JMOS Courtyard Input from Parents 4-15-20

January 14, 2020
Initial AMS/JMOS Site Plan

Ashland School District
Ashland Middle School Addition + Renovation
John Muir Outdoor School Renovation
100 WALKER STREET
07520

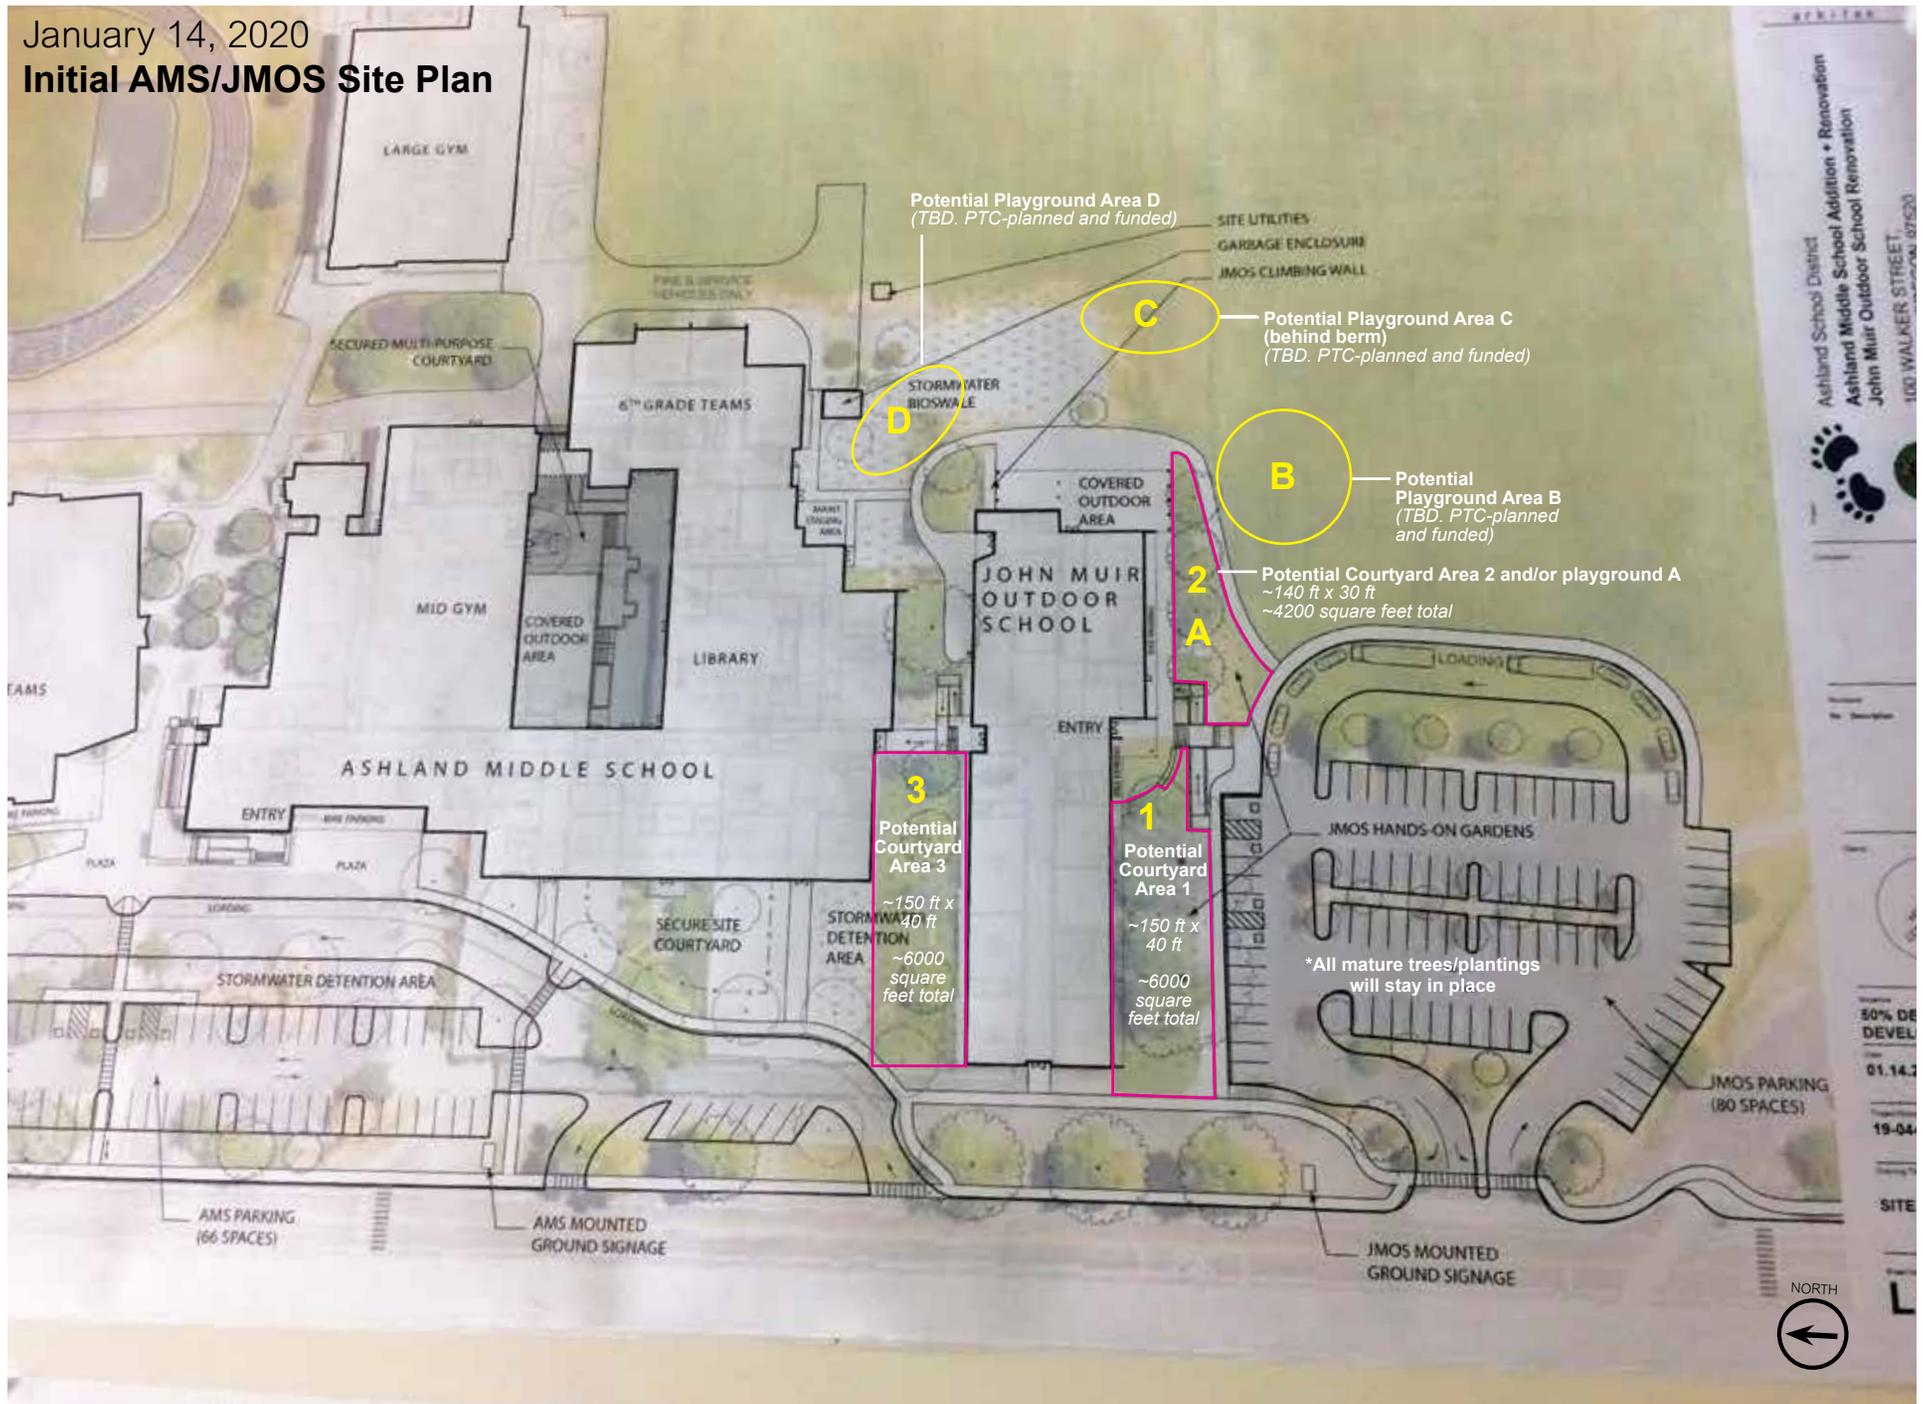
Whichever courtyard area is chosen as the shorter recess area for JoEllen and Randi's classes will need to have some kind of fencing, especially courtyard 1 as it borders parking/drivethrough areas on two sides.

Where will the pick up area be and can we design it at this point to be more cohesive and less frustrating for adult monitors and parents to keep an eye or find their kids?

I like the playground areas B and C better, as they are closer to the upper field areas. I would prefer seeing some trees planted just beyond the covered area, to create a sheltered by nature feeling to the end of our building/area, around playground area C, and then use playground area B for the playground.
